**Seattle
Design
Commission**

**MINUTES OF THE MEETING
September 6, 2007**

6 September 2007 Project: South Lander Street Grade Separation

6 September 2007 Project: SR-519 Grade Separation- Phase II

South Lander Street Cross Section

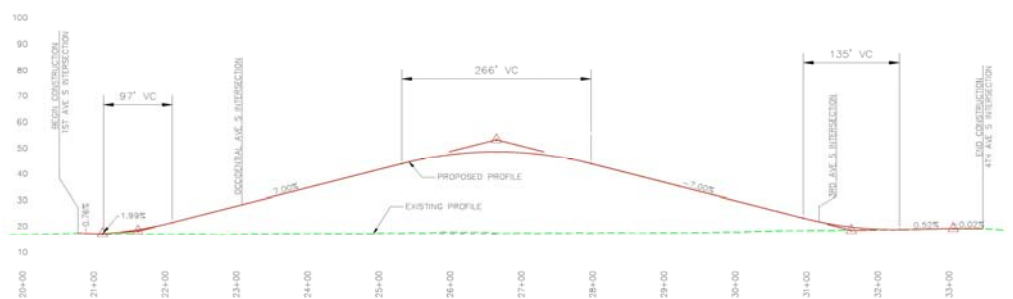
- **Appreciate the level of detail provided in the presentation and understand the complexity of the project.**
- **For future presentations, would appreciate more east-west cross sections and profiles of the roadway to help illustrate the height and bulk of changes it will have on this area.**

- Include longitudinal section (such as an east-west profile to scale). There also needs to be design correspondence to be comprehensive (railing, lighting, signage, etc.) rather than piecemeal the design (this is an area that City Design may need to step in for). Shelter and respite for pedestrians are important. The team can also increase benefits and share costs by partnering with sustainability staff.
- In the next presentation, perhaps SDOT will provide guidelines for state route 519 that this project can glean from.
- Suggest the use of a lighter, more visible six foot sidewalk and 1st Avenue South gateway will make it cohesive.
 - The team will ask Starbucks for help on this matter.

Complete Streets: Competing Modes of Transportation

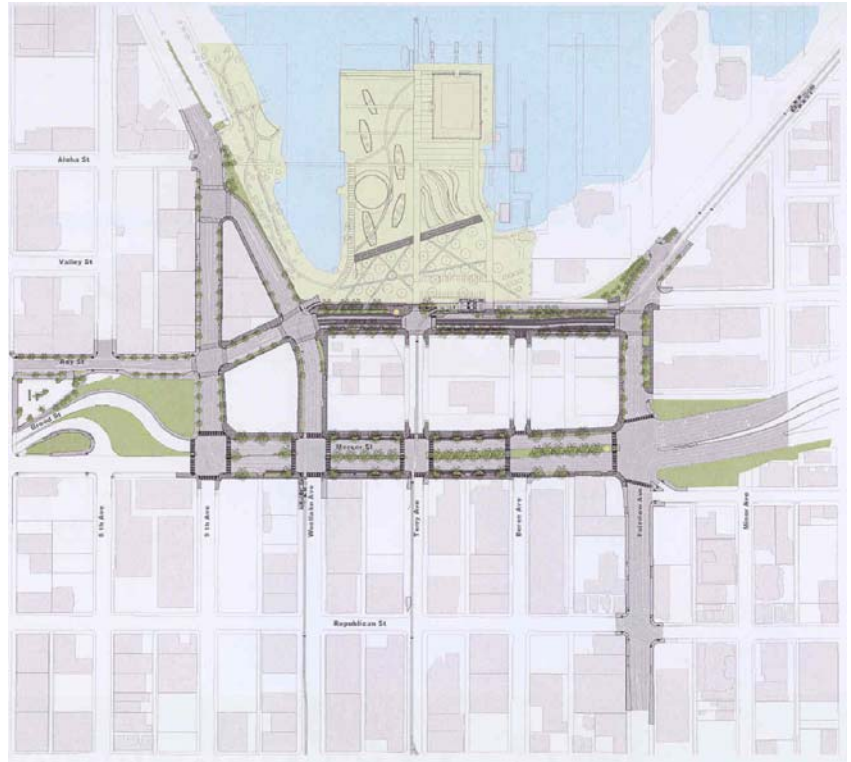
- **Although Mercer Corridor and Valley Street are distinct streets, there should still be a strong palette or character to connect them.**
- **Tree selection on Valley Street needs additional review. Also, reconsider whether different treatment of street trees on parking strips on Valley and Mercer is necessary.**

- Design Commission urban form charrette in November for SLU.
- Reduce palette to make overall cohesiveness.
- Sidewalk widths are generous; the tree in the parking strip is vulnerable to car crashes? Why not put in green fingers on Valley?
